Ilam Road Cycle Facility

Design, Performance and Safety Review

Prepared for Christchurch City Council
December 2013/4

Figure 1: Cross-Section Details of Cycleway Kerb Separators

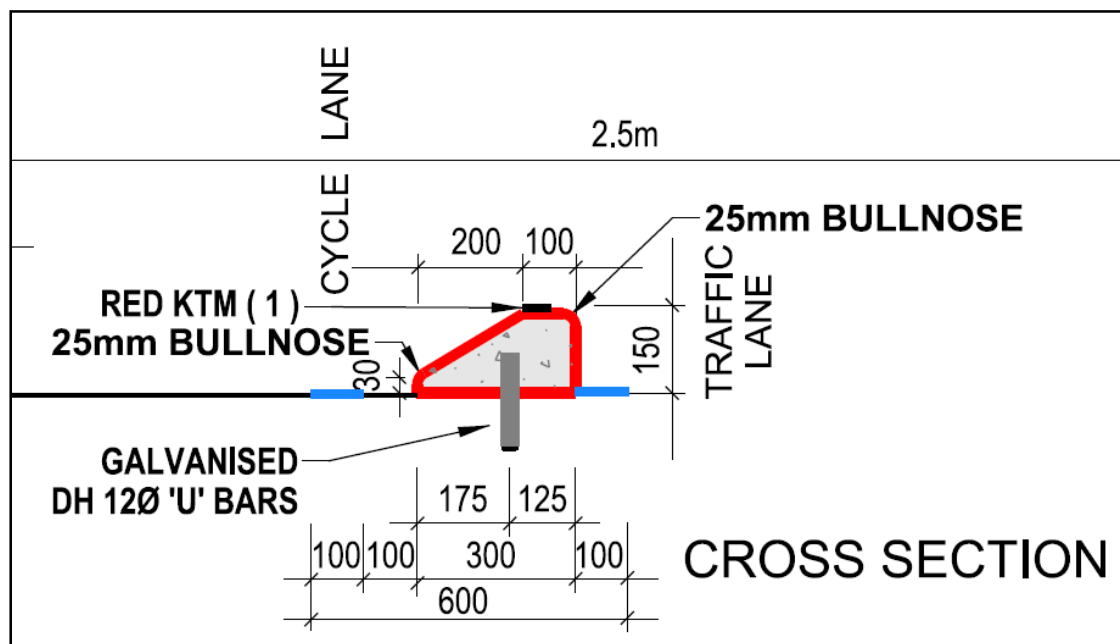
The SAT's understanding was that the selection of the kerb profile template was a somewhat pragmatic decision making use of an existing standard design for mountable kerbs surrounding traffic islands (CCC 2010). Some discussion had been undertaken with supplier RTL about other separator design options, but it was felt that these were too limited. It is notable that vertical "flexi-posts" used in trials elsewhere around the city (Koorey *et al* 2013) were not considered suitable for in this situation. It is also significant that details about the design for these separators were not presented as part of the public consultation process for the Ilam Road project.

A key issue (identified elsewhere in this report too) was the non-mountable nature of the separators for motor vehicles. Whilst this clearly helped to discourage encroachment into the cycleways, it resulted in significant damage to both vehicle and separator when there was a collision (of which it was evident there were many to date). This goes against the principles of a "forgiving" road environment for all road users, as well as contributing to a high separator maintenance cost.

Alternative cycleway separator designs should be trialled in the next few future separated cycleways with a view to identifying one or two designs to be used as standard throughout the city. Prior assessment of potential options should include public feedback as well as comment from contractors and maintenance operators about any likely practical implications of installing and maintaining the separators.

Photo 9: Pedestrian Sight line reduced by shuttering effect created by pedestrian lighting pole and post.

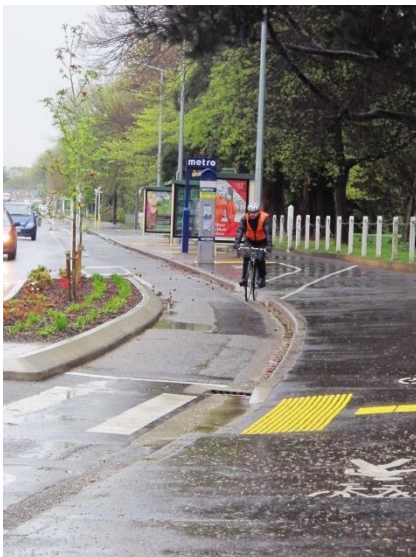
1. Pedestrian sight line blocked by shuttering effect created by lamp post and hazard marker post (refer to Photo 7 and Photo 8)
2. Sight lines blocked or restricted due to new planting (adjacent trees etc) Refer Photo 9)

Photo 7: Pedestrian Sight line reduced by shuttering effect created by pedestrian lighting pole and post.

Photo 8: Hazard marker could have been mounted lower (refer to arrow), eliminating sight line obstruction.

Photo 10: Hazard marker could have been mounted lower (refer to arrow), eliminating sight line obstruction.

Intervisibility sight lines should form a specific item to be checked in the design phase, and parking, planting and roadside objects should be positioned to avoid sight line restrictions.

Photo 13: Photo of Cycle use of off – road facility (opposite University Drive). Note obstruction to inter-visibility caused by advertising and bus shelters.

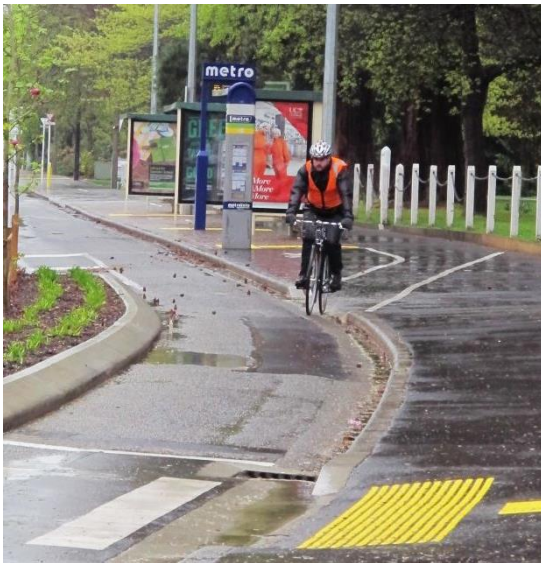
Photo 14: Photo of Cycle use of off – road facility (South of Montana Ave). Note obstruction to inter-visibility caused by advertising and bus shelters.

The off road facilities around the existing bus stops has many locations where people milling around waiting for buses are masked from sight by the cyclist by the bus shelters. The bus shelters installed have advertising on the return ends, obstructing inter-visibility between the cyclist and the pedestrian. There is a risk that pedestrians from the bus could walk direct into the path of cyclists, unaware of approaching cycles travelling at speed. Refer to Photo 13 and Photo 14 below.

Bus stop form should be a specific point of focus during the design phase. All possible actions should be taken to ensure that the bus stops designed minimise conflicts.
